SUBJECT: Forwards response to 860708 request for addl info re
 emergency diesel generator load evaluation.

Re: Turkey Point Units 3 and 4
Docket Nos. 50-250 and 50-251
Request for Additional Information
Emergency Diesel Generator Load Evaluation
NRC TAC Nos. 61211 and 61212

Following are Florida Power & Light Company responses to the NRC's July 8, 1986 Request for Additional Information (RAI) regarding the Emergency Diesel Generator Load Evaluation. For your convenience, the response to each question immediately follows the duplicated RAI.

FIGURE RAI-2

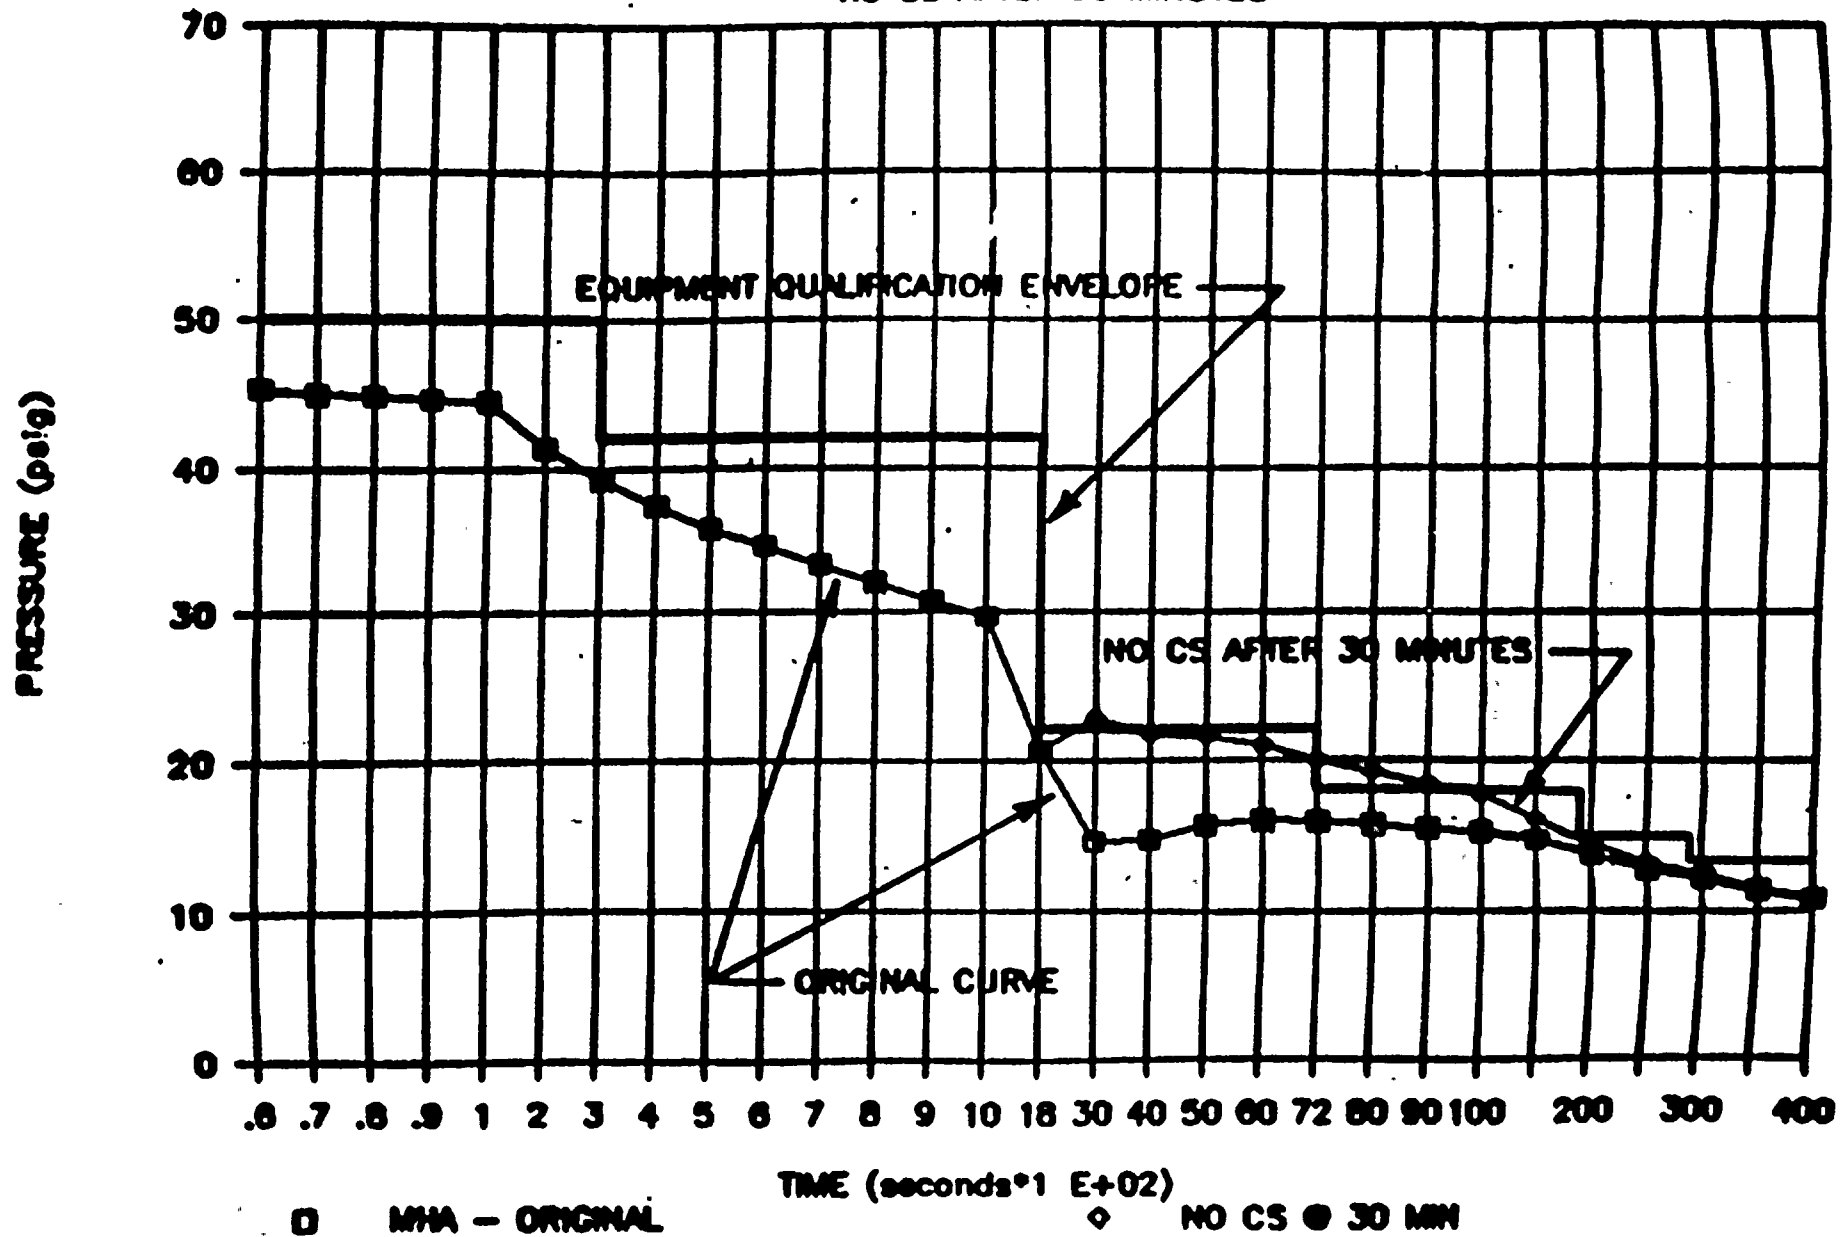
Provide the plot of containment atmosphere pressure that corresponds with the plot of containment atmosphere temperature provided as Figure 3 in the June 12, 1986, submittal.

The requested pressure versus time curve is attached as Figure RAI-2.

Containment pressure in psig, as shown on Figure RAI-2, represents the total of the air and steam partial pressures in the steam/air mixture. Temperature of the mixture is the saturation temperature at the steam partial pressure and is provided as Figure 3 of the EDG Load Evaluation.
